2009
GARDEN PLAIN HIGH SCHOOL - NEW GYM
GARDEN PLAIN, KANSAS
RENWICK UNIFIED SCHOOL DISTRICT 267

DRAWINGS ISSUED		
NO.	DATE	ITEM ISSUED
1	04/28	ADDENDUM 1

SHEET
A3.7
OF 1 SHEETS

1 POLE VAULT BOX PLAN
SCALE 3/4" = 1'-0"

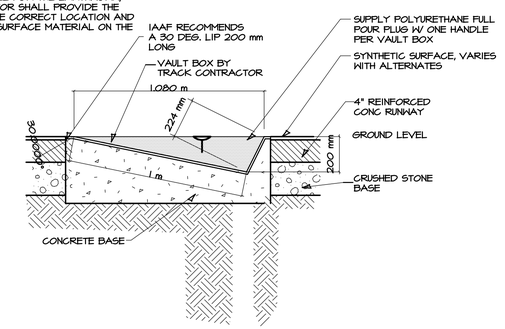
THE GENERAL CONTRACTOR FOR THE NEW GYM SHALL BE RESPONSIBLE FOR THE EARTHWORK, SUB-SURFACE STABILIZATION AND CONCRETE. THE TRACK CONTRACTOR SHALL PROVIDE THE G.C. THE VAULT BOX AND COORDINATE SETTING THE VAULT BOX IN THE CORRECT LOCATION AND HEIGHT. THE TRACK CONTRACTOR SHALL BE RESPONSIBLE FOR THE SURFACE MATERIAL ON THE RUNWAYS.

3 POLE VAULT LANDING
SCALE 1/8" = 1'-0"

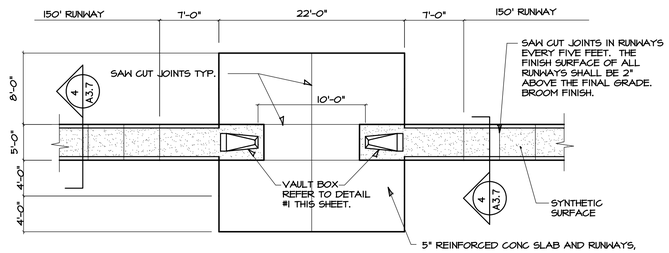
CONSTRUCT LANDING AREA PAD AS ONE CONC. PAD, FINISH ELEVATION TO BE THE THICKNESS OF THE SURFACE MATERIAL (1/2" VERIFY) ABOVE RUNWAY BUT LEVEL. NO JOINTS IN FRONT OF BOX. BOX TO BE INSTALLED THE THICKNESS OF THE SURFACE MATERIAL (1/2" VERIFY) ABOVE RUNWAY.

4 CONCRETE RUNWAY
SCALE 1/2" = 1'-0"

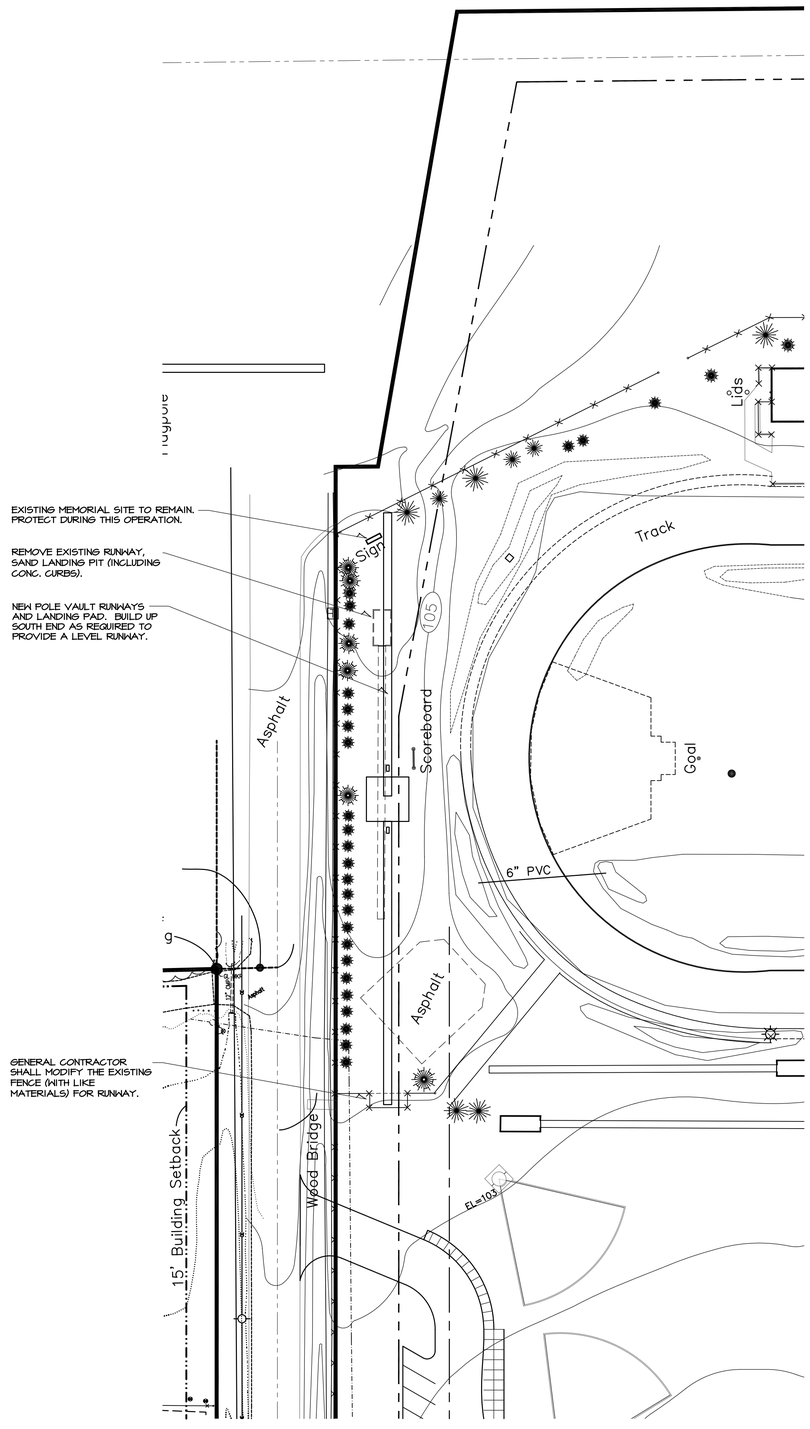
THE RUNWAYS WILL BE CONSTRUCTED WITH CONCRETE.
ADJUST FINAL GRADING TO BE WITHIN 2" OF THE TOP OF THE PAVING SURFACE
